**Proposal for the amendment to the document,  
ECE/TRANS/WP.29/GRSP/2023/26, proposal for  
Corrigendum 1 to Amendment 1 to  
UN Global Technical Regulation No 13 (Hydrogen and Fuel  
Cell Vehicles) \***

**Submitted by the expert of the Informal Working Group on UN Global  
Technical Regulation No. 13, Phase 2**

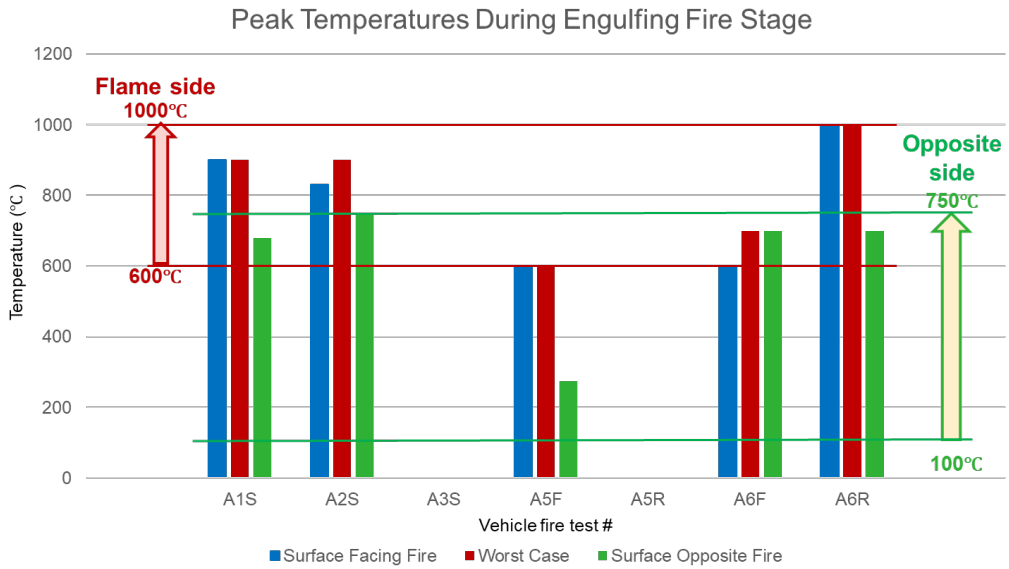
Figure 12 in paragraph 88, amend to read (corrected labels, no changes to values):
